RE: Oakdale West Industrial Estate (SSD 7348) Modification 5 – Transport Statement

In this context, Ason Group has been tasked to review general parking compliance of the following revision of the plans and to assess the trafficable impacts of the modification -

■ SBA Architects, 15117 OAK DA-10 Z Site Plan, Revision Z, dated 1st July 2020.

Attachment 1
Site Plan

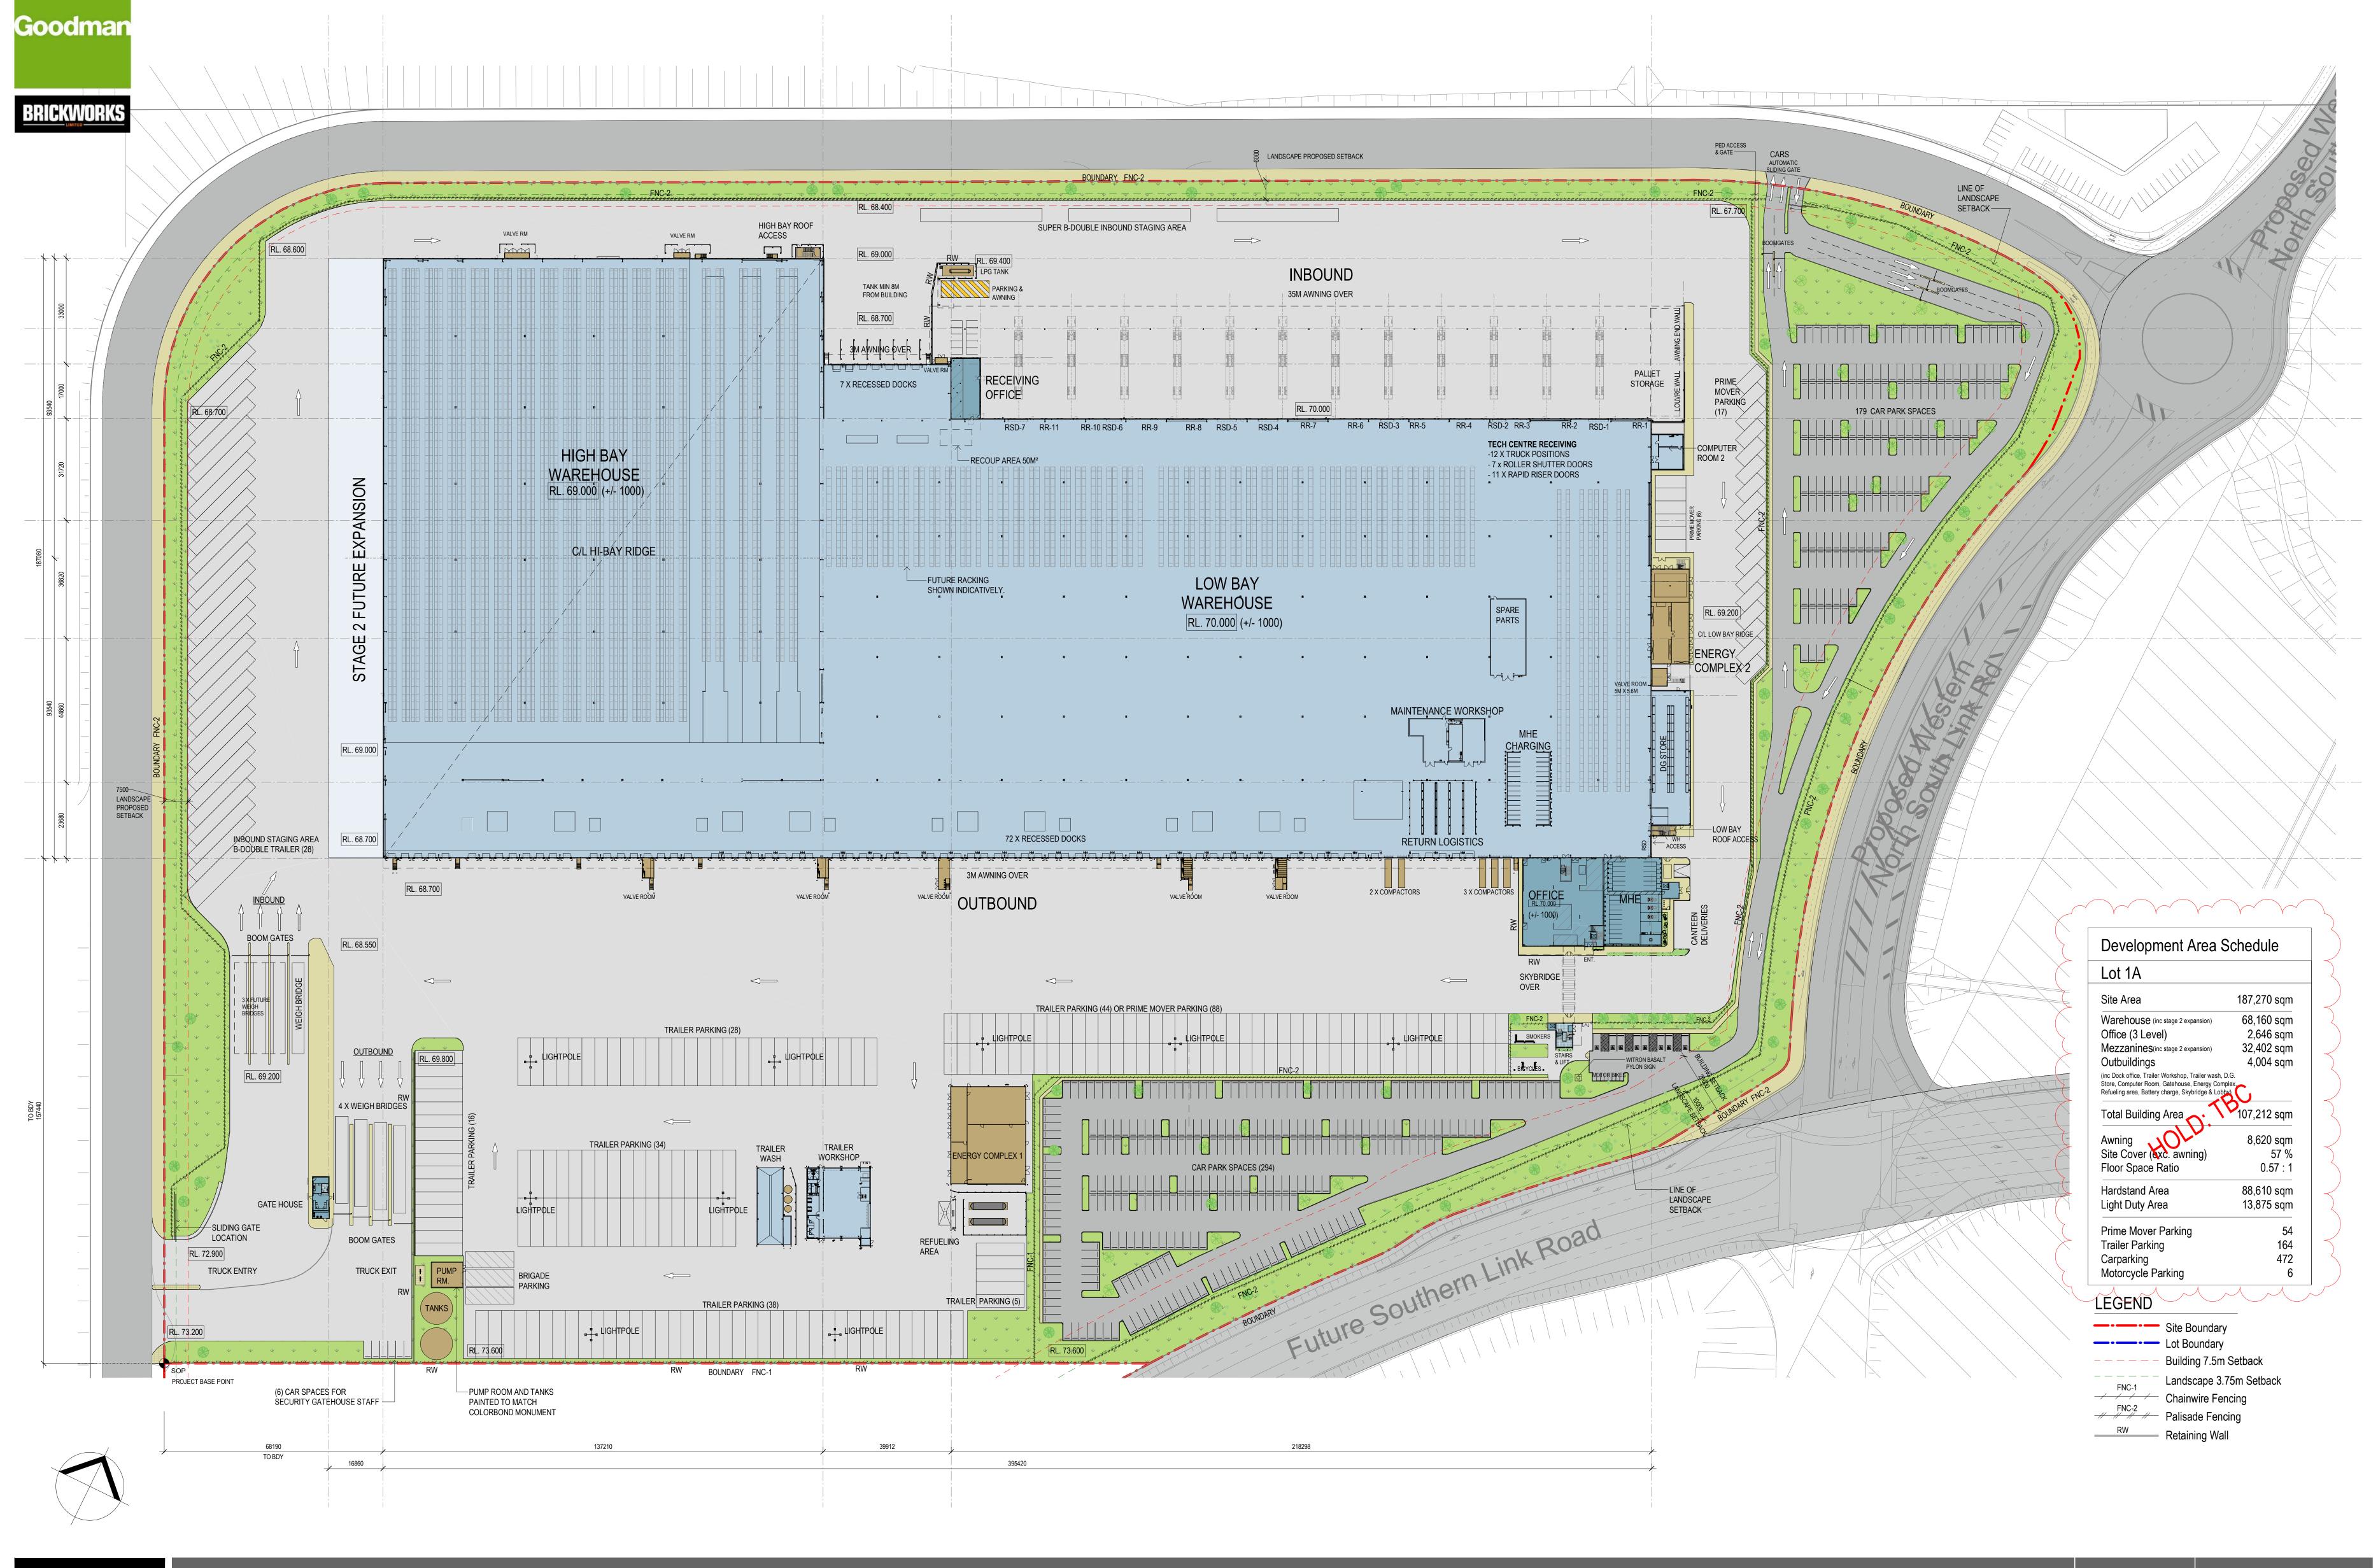
The undertaken review of the Lot 1A access and car parking area demonstrate general compliance in accordance with the requirements of *AS2890.1*. Notwithstanding, full compliance with *AS2890.1* would be expected to form a standard condition of consent for approval and can readily be provided as part of the Construction Certificate stage of the project.

A queueing analysis of the additional security checkpoints has been undertaken to determine that there would be no substantial queueing of vehicles entering the parking lots that may impact traffic on the road frontage. Notwithstanding, the sliding gate located at the entry crossover shall remain open during operational hours.
